CORNELL COMMERCIAL SUBDIVISION

Engineering Comments: FINAL PLAT COMMENTS (should be addressed prior to submitting the FINAL PLAT for review and/or signature by the City Engineer):

DETAIL SITE PLAN

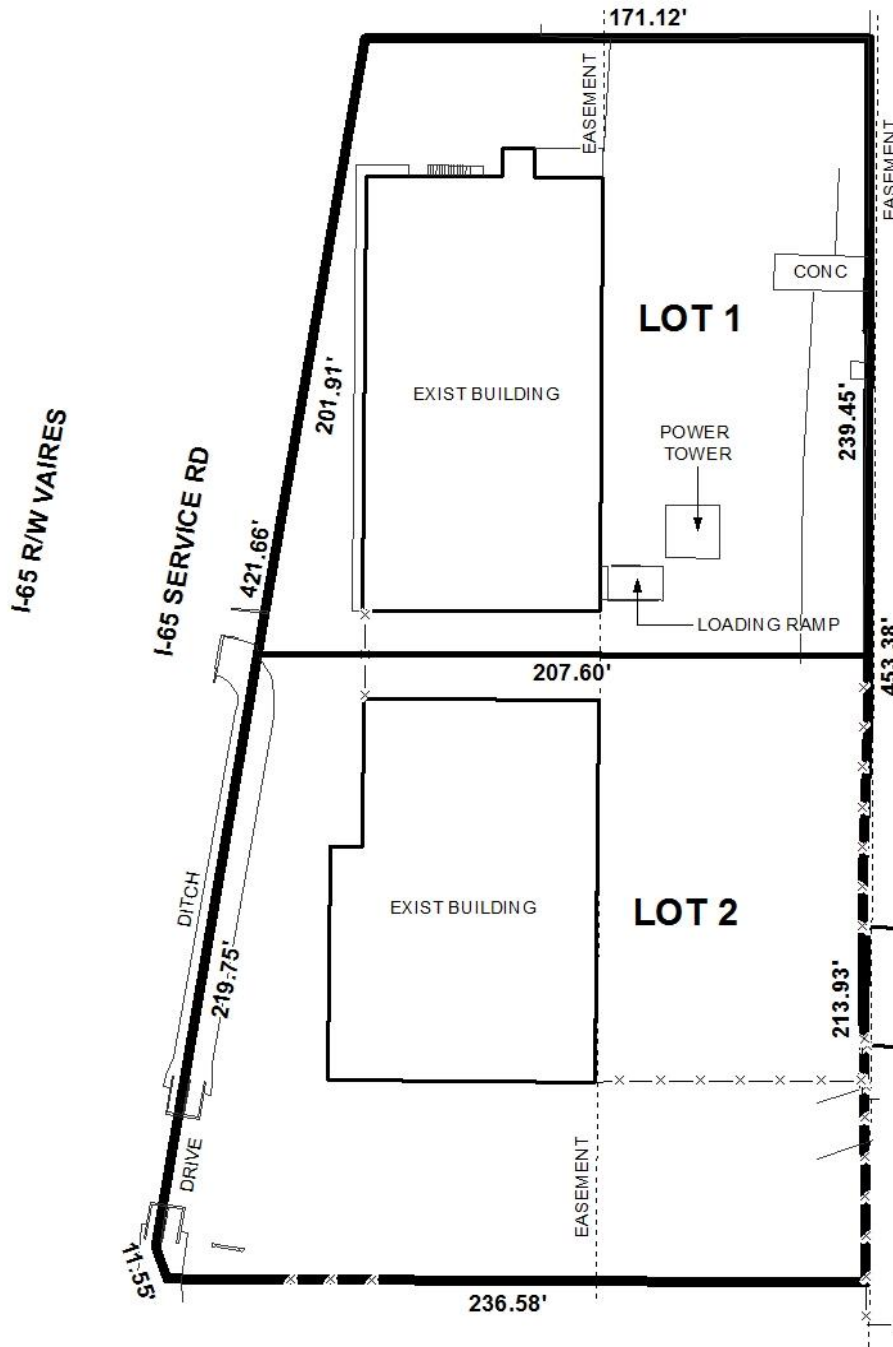
- E. Provide the Owner's (notarized), Planning Commission, and Traffic Engineering signatures.
- F. The proposed subdivision will need to include a 5' drainage easement along the frontage of LOT 1.

- G. The proposed subdivision will need to include a 15' drainage easement along the frontage of LOT 2.
- H. Add a note to the SUBDIVISION PLAT stating that a Land Disturbance permit will be required for any land disturbing activity in accordance with Mobile City Code, Chapter 17, Storm Water Management and Flood Control; the City of Mobile, Alabama Flood Plain Management Plan (1984); and, the Rules For Erosion and Sedimentation Control and Storm Water Runoff Control.

The proposed lot fronts East Interstate 65 Service Road North. The preliminary plat illustrates a 150' right-of-way width from the centerline of Interstate 65, if approved, should be retained on the Final Plat.

A 25-foot minimum building setback line is not depicted on the preliminary plat along the Interstate 65 Service Road. It should also be noted that the preliminary plat illustrates buildings

that encroach in the required setbacks. If approved, the 25' building setback line should be illustrated along Interstate 65 Service Road.

It should be noted that there is existing cross-access between the two proposed lots, both in the front and in the rear of the existing buildings. Additionally, there is access to the rear of properties that front Furr Street. The cross-access is typically only allowed as part of a Planned Unit Development, thus a PUD application should also be submitted for consideration by the Planning Commission.
